PLAN COMMISSION

August 14, 2023 5:30 p.m.
Council Chambers, Room #115
Hybrid Zoom Link:

PETITIONS:**PUD-18-23 Sudbury Development Partners LLC**

**BLOOMINGTON PLAN COMMISSION
STAFF REPORT
Location: S. Weimer Road**

Image One August

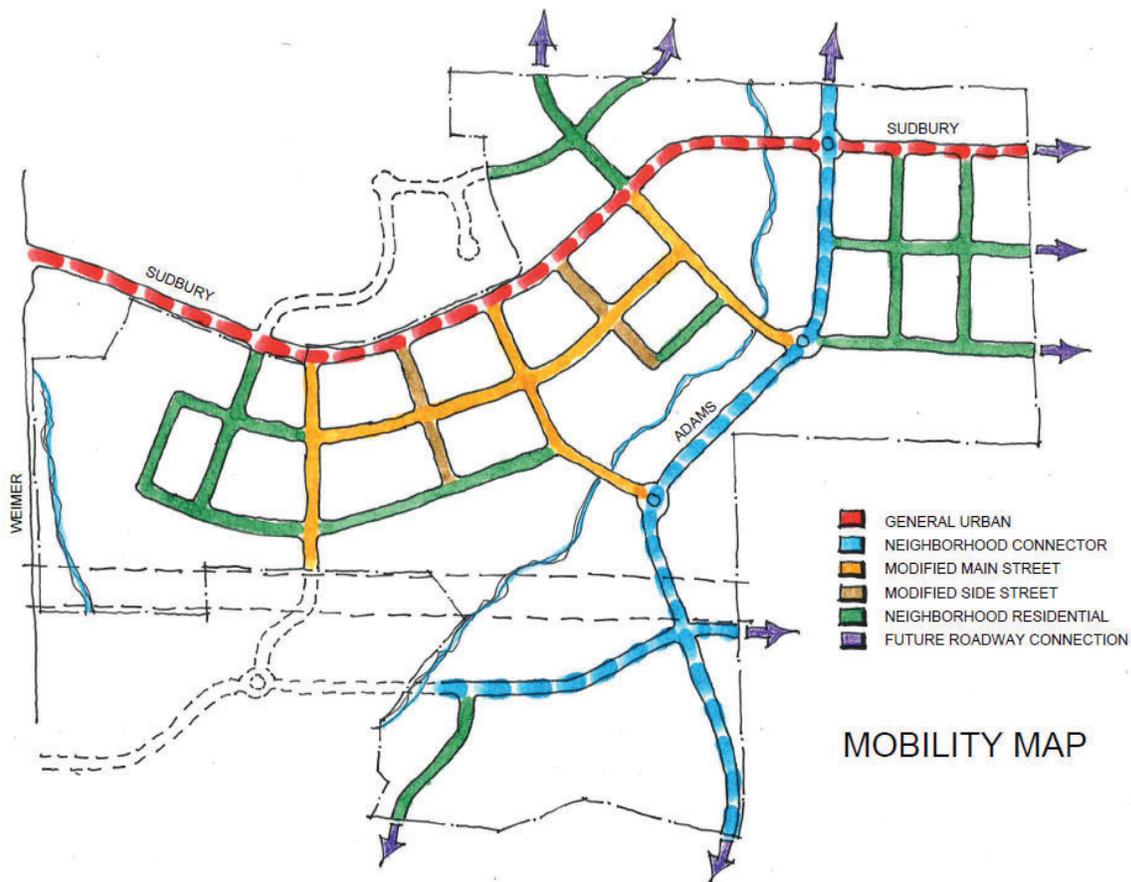
The image below indicates that the roadway configuration has changed since July, with less roadways shown. All of the points of exit from the site have been maintained with three added to the east and one to the north.

1. The southernmost connection in the Transportation Plan raises questions.
 - a. The petitioner is proposing a trail connection to Weimer Road. In consultation with the Parks and Recreation Department, the petitioner may be asked to build the entirety of that trail on their property, bypassing the property to the southwest.
2. The proposal is not more gridded than the July version, but does provide additional external connections.
3. Same question from July: Adams Street to the north is privately maintained in the County. Have discussions been had with that entity?
4. A stub to the east is provided.
5. Same question from July: When the property is subdivided, platting and construction of

the roads in the Transportation Plan will be triggered. The expectation is that they are built within the time allowed by the UDO, which is a matter of a few years. Does phasing for the roads need to be included in the PUD separate from the neighborhoods?

Image Three

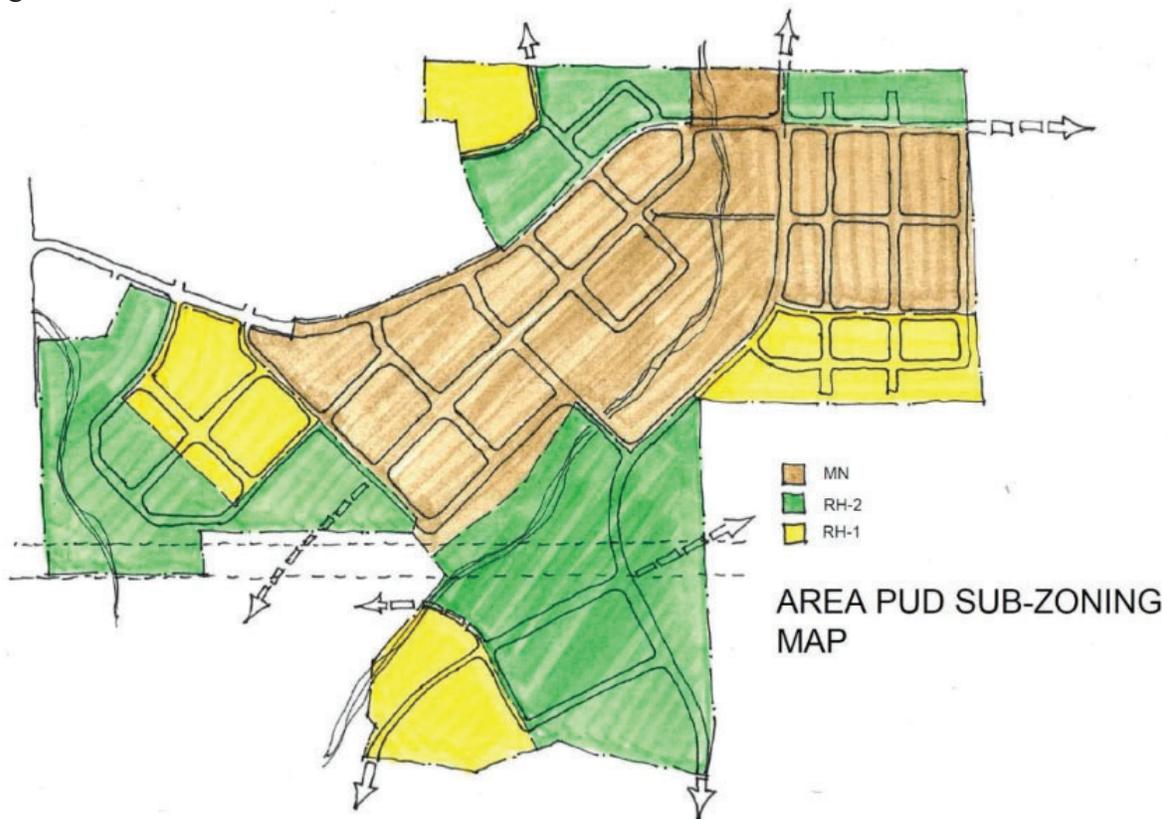
The petitioner has identified two zoning districts from the UDO that they will use as the base for their regulations, Mixed-Use Neighborhood Scale (MN) and Residential High-Density Multifamily (RH). As is typical in a Planned Unit Development, the petitioner has proposed a number of changes to these districts in the PUD. They are proposing development standards and uses that differ from the UDO. They are also proposing some regulations that are verbatim from the UDO that they would like to enshrine for this area, to avoid any changes to the UDO affecting this development in the lifetime of its development. The petitioner is proposing three separate districts, RH1, RH2, and MN, each an amended version of the original in the PUD. The petitioner is proposing to utilize the three district types (RH1, RH2, and MN) in each of the neighborhoods, as seen in Image Three, below, from the District Ordinance. Some issues raised by the Department for discussion are listed below Image Three.

1. In a typical zoning code, each district has a set of development standards AND a set of allowed uses. Those standards and uses apply to the entirety of the district, unless the Dimensional Standards Table or Use Table is augmented by Use-Specific Standards. The petitioner is proposing that allowed uses be regulated by separate spatial areas, meaning that while all MN areas have the same development standards, they do not all have the same allowed uses. The uses need to be uniform in each of district, but can be augmented by Use-Specific Standards. The petitioner is working toward this goal.

2. In most PUDs, petitioners identify those standards that do not meet the Unified Development Ordinance. Per 20.06.070(c)(5)(B), "to the extent permitted by Section 20.01.040(b) (Effect of Change in the Law after Filing of Complete Petition), changes to the UDO that alter any development standards for which the PUD district ordinance is

silent shall apply to portions of the PUD for which an approved site plan has not been approved before the date of the UDO change.” The petitioner has included many regulations from the UDO verbatim in their district ordinance, in order to ‘freeze’ those regulations in time. While the Department is sympathetic to the desire to have total control over the design of future development, we think that the amount of things currently included that are verbatim from the UDO is excessive, and also creates confusion about which regulations are actually different. We would like to see the duplication of the UDO drastically reduced. Not only because it creates confusion about which regulations are proposed to be changed, but also because it may create confusion about which aspects the PUD is silent on, and revert to the UDO, as described in the reference above. For example, if the petitioner only submits a list of amended Primary Materials with no mention of Secondary Materials, as they have done in this instance, are they expecting no Secondary Materials? Or are they expecting the Secondary Materials from the UDO? If there is a section in the UDO with 7 subsections, and the petitioner submits 2 amended and only 2 additional, are the other 3 moot? Or do they revert to the UDO? The style that is in the current draft will not work long-term, and needs to be amended. The best way to do this is to remove large amounts of the verbatim language.

Image Five

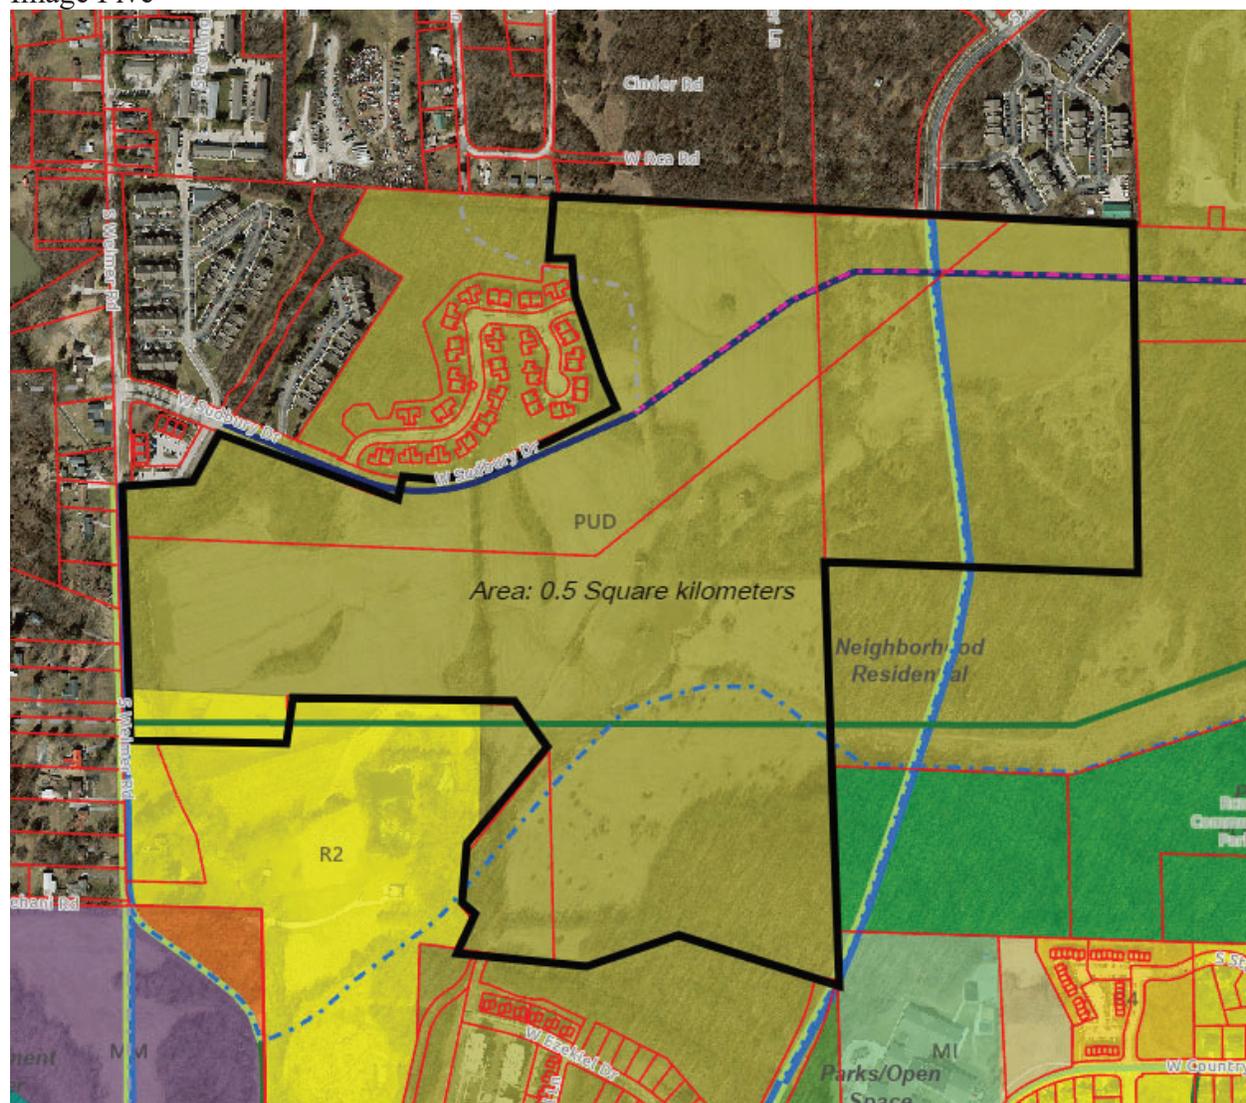
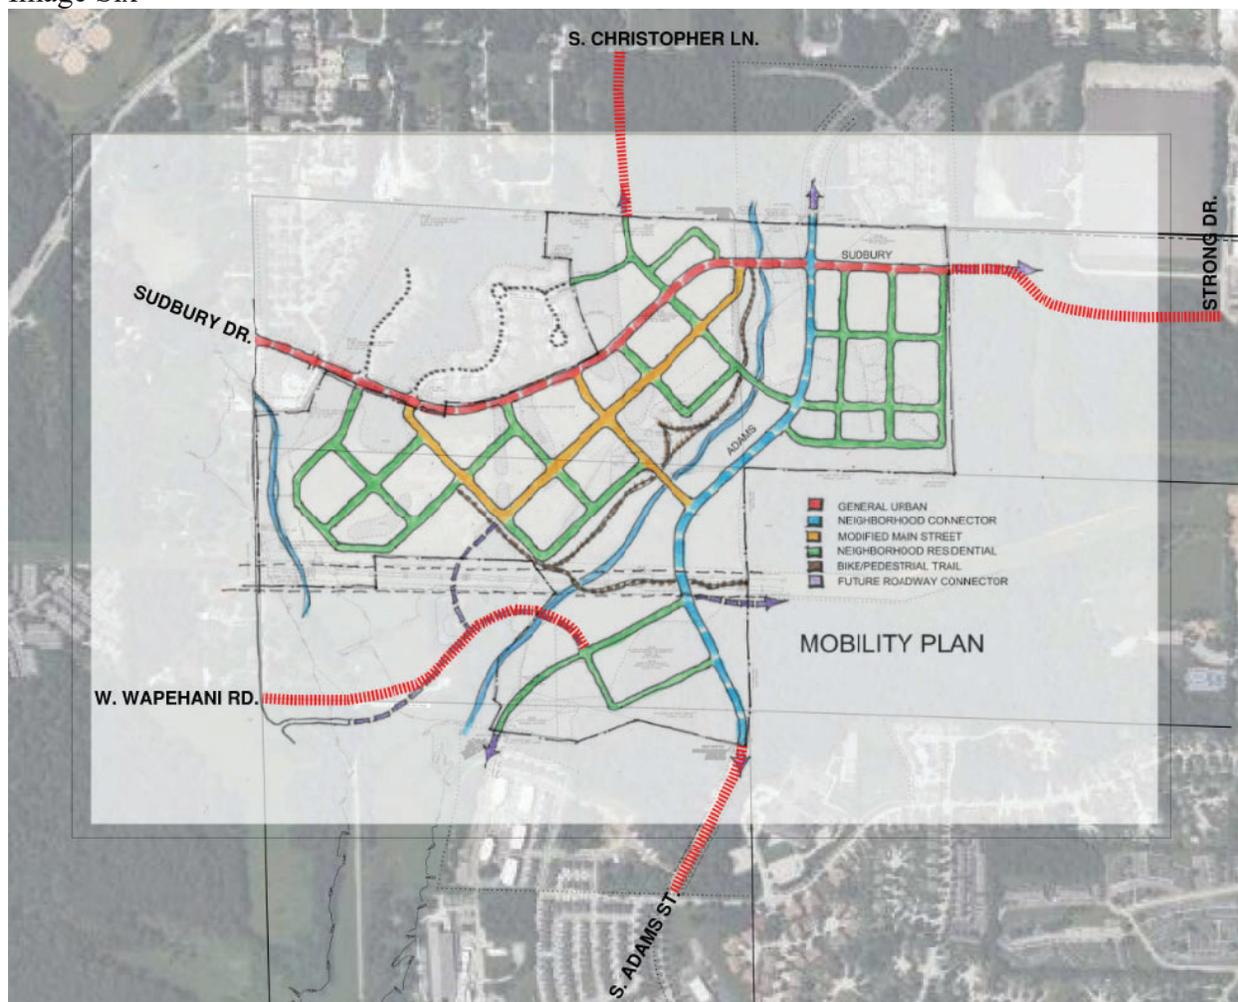
As can be seen in Image Five below, the petition site, outlined in black, has a number of improvements in the adopted Transportation Plan. The northernmost connection is the extension of Sudbury as a General Urban street from the end of the existing W. Sudbury Drive right-of-way to the eastern end of the petition site. (NC-19) That roadway is to contain a protected bike lane. On the eastern side of the petition site, S. Adams Street stubs at both the north and south ends of the petition site, and the Transportation Plan shows a Neighborhood Connector with a bike lane

and multiuse path. (NC-20) The petitioner is including the entirety of the Adams Street connection on their parcel and has worked with the Department and the Engineering Department on a general location. There is a third new right-of-way shown in the Transportation Plan on the southern end of the petition site. (NC-24) That road is shown as a Neighborhood Connector that appears to be aligned with the Duke Energy easement to the east, and moving southwest to connect to the existing Weimer Road right-of-way through a neighboring parcel. Image Six below is from the proposed Preliminary Plan and shows potential right-of-way connections and the surrounding context. Some issues raised by the Department for additional discussion are below Images Five and Six.

The petitioners need to conduct a Traffic Study to determine the possible impacts on surrounding roadways and nearby intersections that a development of this size could bring. The study will need to be done once Indiana University is back in session. Some of the roadways around the site present issues such as limited roadway, a small bridge, or private ownership.

6. The southernmost connection in the Transportation Plan raises questions.
 - a. The western connection in the Transportation Plan is to a portion of Weimer Road that may become a trail in the future, if plans to realign Weimer Road go forward. Does it make more sense to have the roadway built north of the R2 parcel/Duke Energy easement? There is floodplain along Weimer in that area, so would be costly.

- b. The petitioner is showing a connection to the south to meet Breaking A Way. But, the Transportation Plan seems to desire a connection to Weimer, so we do not believe that that connection supplants the need for an NC-24 connection.

9. Do we need a stub to the east on the southern portion of the development site, as is shown in the Transportation Plan?
10. When the property is subdivided, platting and construction of the roads in the Transportation Plan will be triggered. The expectation is that they are built within the time allowed by the UDO, which is a matter of a few years. Does phasing for the roads need to be included in the PUD separate from the neighborhoods?

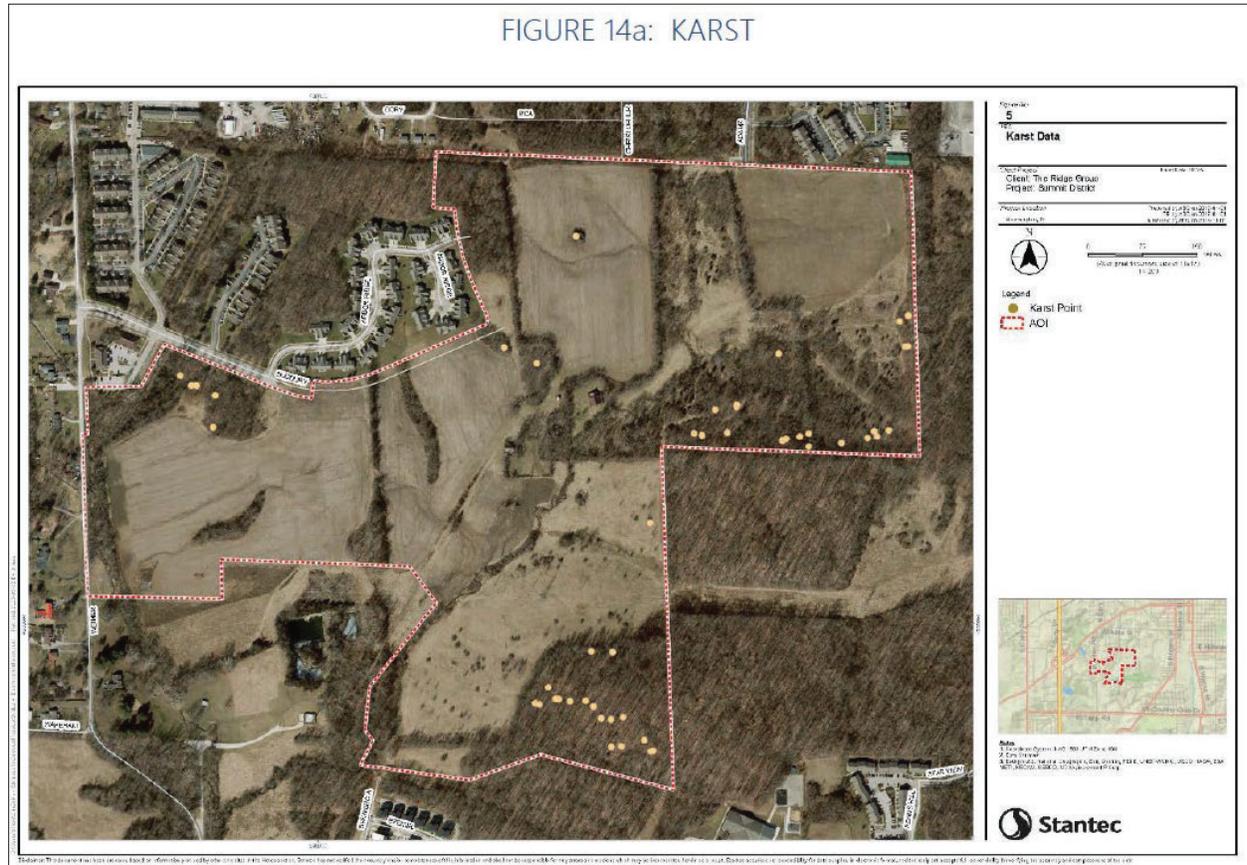
In regard to karst features, the Petitioner (Sudbury Development Partners, LLC) provided a map, “establishing specific environmental site features” (FIGURE 14a: KARST) in its Preliminary Plan. FIGURE 14a: KARST can be found on Page 159 of the meeting packet of the July 10 Plan Commission meeting. See screenshot below for the map provided by the Petitioner.

One can easily count approximately a total of 45 to 48 yellow dots (some adjacent to each other) representing karst features dotted all around the Summit District PUD, with several of them being in very close proximity to each other. It is unclear whether these karsts are surface, subterranean (surface) or compound. A quick search in the PDF did not produce any further explanation from the Petitioner. The Petitioner did not request exceptions on karst, so the Unified Development Ordinance (UDO) of the City of Bloomington applies.
